UNITED STATES PATENT AND TRADEMARK OFFICE

APPLICATION NO.	FILING DATE	FIRST NAMED INVENTOR	ATTORNEY DOCKET NO.	CONFIRMATION NO.
10/780,512	02/17/2004	Tai-Chun Huang	TS03-461	1383
42717	7590	09/19/2005	EXAMINER	
HAYNES AND BOONE, LLP 901 MAIN STREET, SUITE 3100 DALLAS, TX 75202			CHU, CHRIS C	
			ART UNIT	PAPER NUMBER
			2815	
DATE MAILED: 09/19/2005

Office Action Summary

DETAILED ACTION

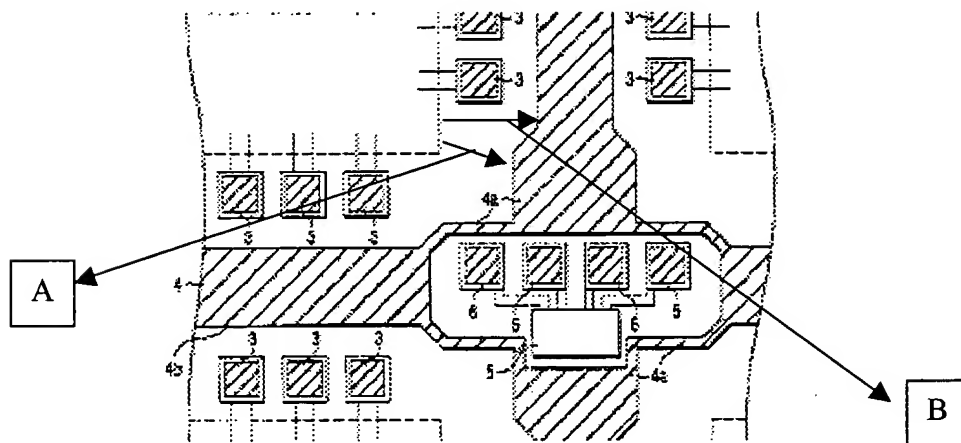
Regarding claim 16, Tsuji et al. discloses in Figure and column 2, lines 45 – 67 a semiconductor device (1; column 2, line 46) comprising:

- semiconductor device structures (any structures inside of the element 4) formed in and on a substrate; and
- a seal ring (4; column 1, line 58 – 60 and Figure show corners and sides of four chips that are separated by the lines 4. Thus, the lines 4 that cover the every corners and sides of a single chip's board lines read as a continuous seal ring.) enclosing said semiconductor device structures forming a single die (2; column 2, line 51),
- wherein a first distance (A) between said semiconductor device structures and a corner portion of said seal ring is smaller than a second distance (B) between said semiconductor device structures and an edge portion of said seal ring (see Figure below).
